Special Use Application: SU-SCH-24-1238

LUHO Meeting Date: July 28, 2025

Development Services Department

Special Use Permit for a Charter

9.0 PROPOSED SITE PLAN (FULL), Page 2 of 3

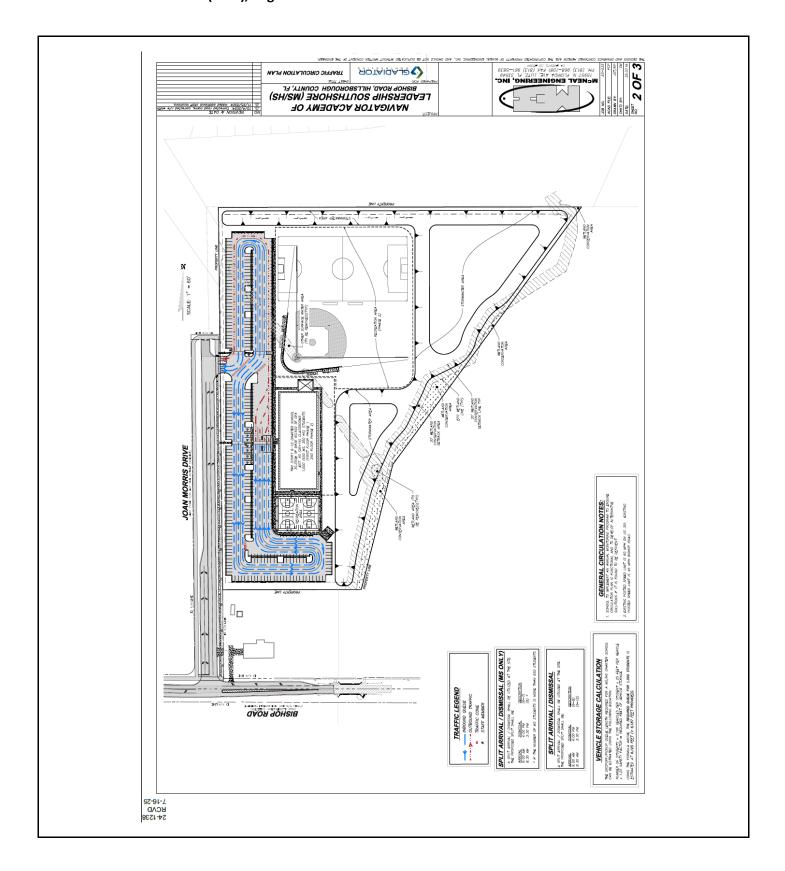
- 15. Access management, vehicle queuing, and staff placement shall occur consistent with the School Circulation Plans (Site Plan, sheet 2 of 3), as applicable. Modifications to these plans may be permitted as approved by Hillsborough County Public Works.

Staff has reviewed the proposed School Circulation Plans and determined that it meets the requirements of Section 6.03.13 of the Hillsborough County LDC, governing vehicle circulation, queuing and parking. The proposed site layout is providing 6,187 linear feet of vehicle stacking to meet the minimum required stacking. On an annual basis and continuing until 1 year after the private school reaches its maximum enrollment of 1,000 students, the developer will be required to assess the sufficiency of queuing both on and off-site at the project access point(s). Should deficiencies be found to exist, the school will be required to work with the Hillsborough County Public Works Dept. to identify and implement additional on or off-site corrective measures.

DRIVEWAY SPACING EXHIBIT

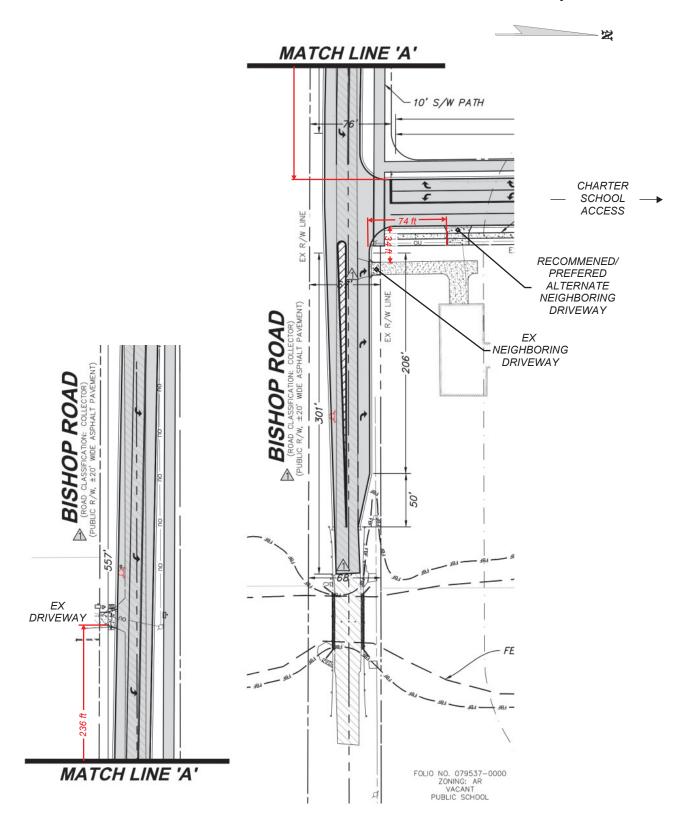
245 feet and is addressed in greater detail herein under the section titled "Requested Administrative Variance".

- (b) The proposed access location should not produce conflicts in the designed location. There are two driveways within 245 feet of this proposed access. However, other than one existing single family home to the east, a safe buffer distance is provided for the immediate surrounding area of Bishop Road, providing the highest level of safety and welfare possible to the future students, and to the surrounding community.
- (c) The designed location would provide reasonable access for the proposed Charter School. Without use of the proposed access location, future use of the parcel for a Charter School is not feasible.

The attached Administrative Variances and Design Exceptions are **Approvable** to me, please include the following people in your response email:

EXHIBIT C - 1/2

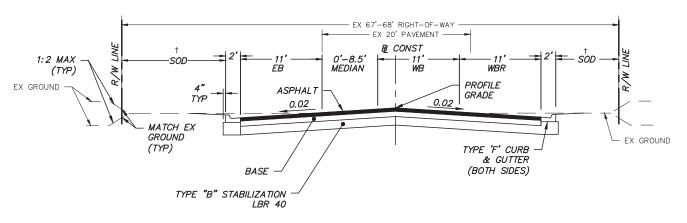
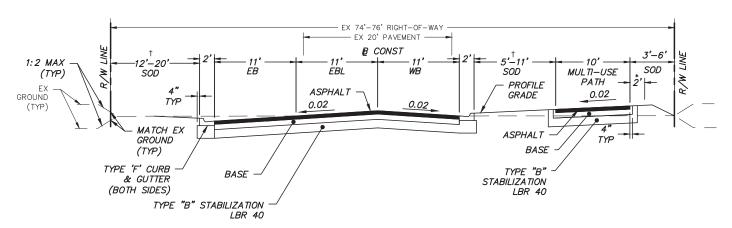
A Design Exception is requested to utilize a roadway design that more closely resembles the (C3-2U) typical section, with a 10-foot shared sidewalk/bicycle path on the north side of Bishop Road. This alternate design would also provide for sidewalk use on the north side of Bishop Road within a constricted corridor, west of Joan Morris Drive. This 10-foot shared sidewalk/bicycle path would also tie into the proposed 10-foot shared sidewalk/bicycle path for the proposed K-5 Charter School site to the west. There are two proposed Bishop Road typical sections, one west of Joan Morris Drive and one east of Joan Morris Drive, provided in Exhibit C.

Based on the information provided by the applicant, this request is: Approved Approved with Conditions Disapproved Michael J. Williams, PE, County Engineer Hillsborough County Development Review Division

EXHIBIT C

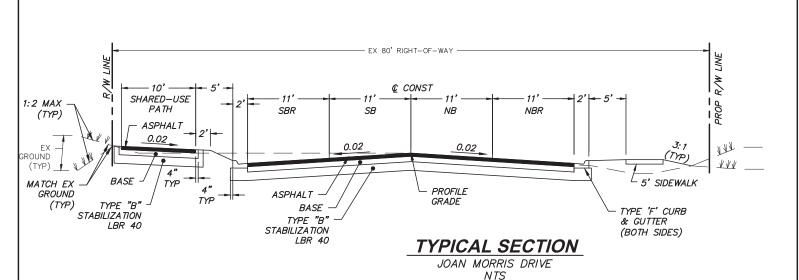
This alternate design would also provide for a sidewalk on the east side. The 10-foot shared sidewalk/bicycle path would tie into the proposed 10-foot shared sidewalk/bicycle path to the south on Bishop Road. The proposed typical section is provided in **Exhibit C**.

Michael J. Williams, PE, County Engineer Hillsborough County Development Review Division
